Alterations and Extension
79 Kingsfield Drive
Didsbury
M20 6HX

Proposed Section

Drg No
79.KD.07

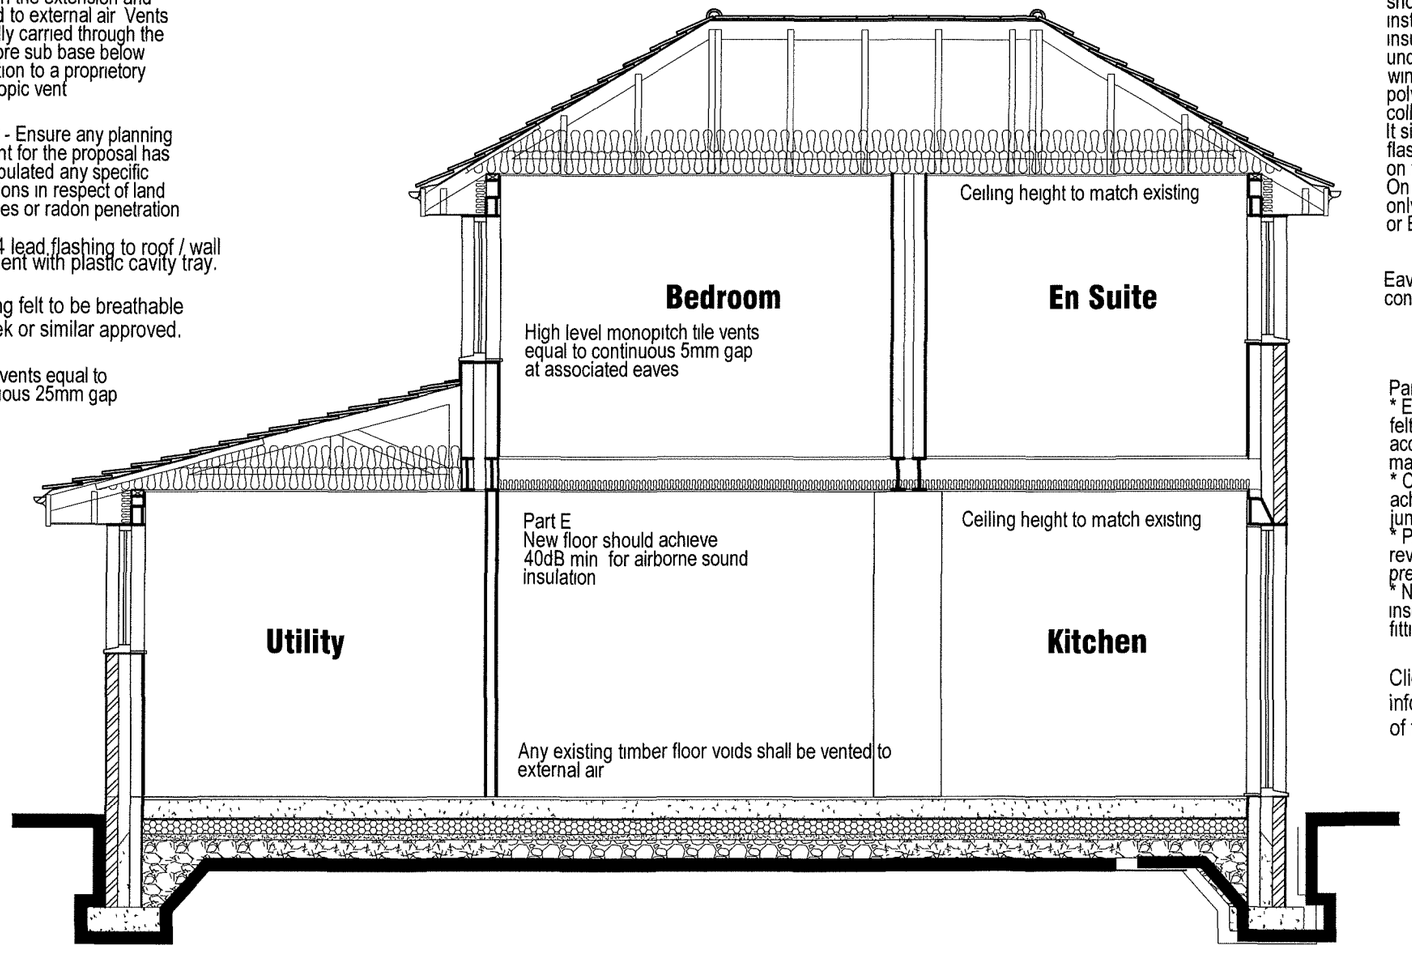
Part C
Profile of roof tiles to be suitable for pitch

Part A - Ensure adequate lateral support at roof level Fit 38 x 6 galv MS straps at roof and ceiling level min 1 8m centres over min 3 no trusses.

Part C - ensure tiles are suitable for pitch

Part C - Any existing sub floor ventilation shall be maintained through the extension and vented to external air Vents typically carried through the hardcore sub base below insulation to a proprietory telescopic vent

Part C - Ensure any planning consent for the proposal has not stipulated any specific conditions in respect of land fill gases or radon penetration

Supporting truss calculations shall be forwarded to Building Control.

Part C
Velux - rooflights.
All components should be installed strictly in accordance with the Velux installers handbook
The following components should be incorporated in the installation- -BDX(frame insulation collar), BFX (underfelt collar), ZZZ196 (wind tightness set), BBX (polythene vapour barrier collar).
It si s essential that the correct flashing kit is selected based on the tile type and roof pitch. On pitches less than 20 deg only flashing kits EDW, EDL, or EDE should be used

Part C
* Ensure breathable roofing felt is laid strictly in accordance with manufacturers instructions.
* Continuity of insulation is acheived at roof/ wall junctions.
* Provision of insulated reveals to Velux windows to prevent cold bridging
* No penetration of roof insulation by recessed light fittings.

Client/ contractor to inform Building Control of tile specification

Existing structure and foundations affected by increased loads shall be exposed for inspection and upgraded as required by and to the satisfaction of the Building Control

Any existing timber floor voids shall be vented to external air
